RISO INC. TECHNICAL INFORMATION BULLETIN

Subject: Drum PCB Cover

Bulletin No: 50

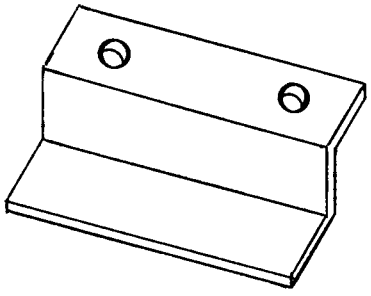
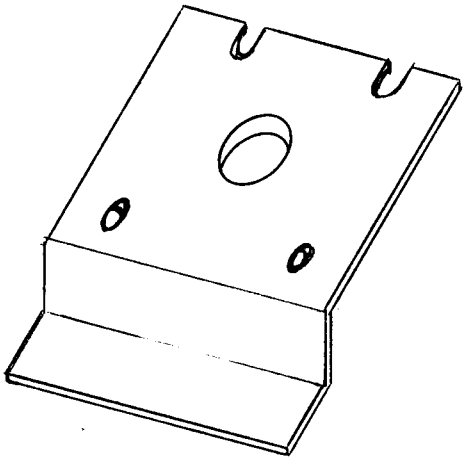
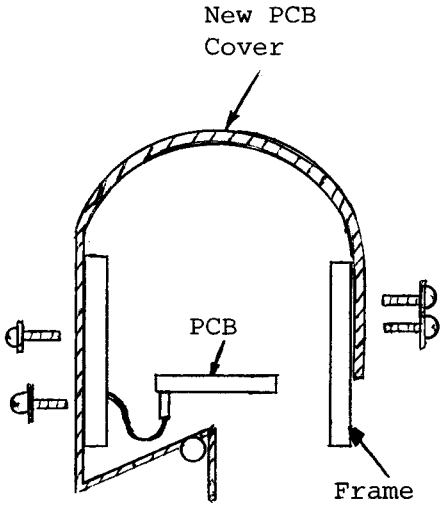
Drum PCB cover has been changed in design to cover the Ink Pump Unit and Drum PCB.

Purpose: Added to protect the drum PCB from ink splash

Old Part: 002-12243

New Part: 007-12124
